RECALL CAMPAIGN
INSTRUCTIONS

REF. NO. C24000080

**REPLACEMENT OF BRAKE FLUID
RESERVOIR CAP**

MODEL YEARS 2021 - 2022

New Adhesive Sticker

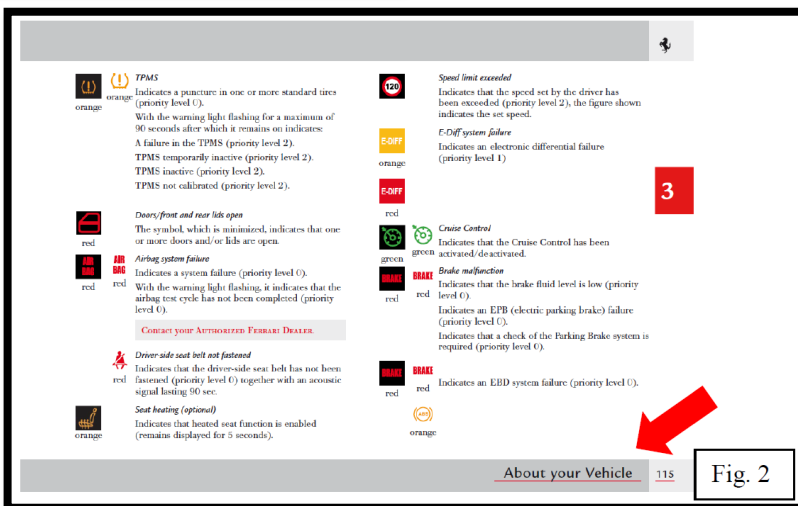
Please find below the proper location and instructions on how to insert the provided sticker into the Owner's Manual (PN: 079641778)

The sticker must be placed on the page shown above in the Owner's Manual. This page is located in the **"About Your Vehicle"** section where the warning lights on the instrument panel are described. Please be sure to attach it to the page with the **"Low Brake Fluid"** description as shown above in Fig. 2.

Once you locate the proper page, remove the adhesive protector off of the back of the sticker. Ensure there is no residue or other particles on the page that may inhibit the longevity of adhesion to the page. Place the sticker to allow the bottom of the sticker to lay directly above the gray margin at the bottom of the page that contains the text **"About your Vehicle"**.

Once applied, apply pressure across the whole strip of 'glue' to confirm the sticker has been properly mated to the page.
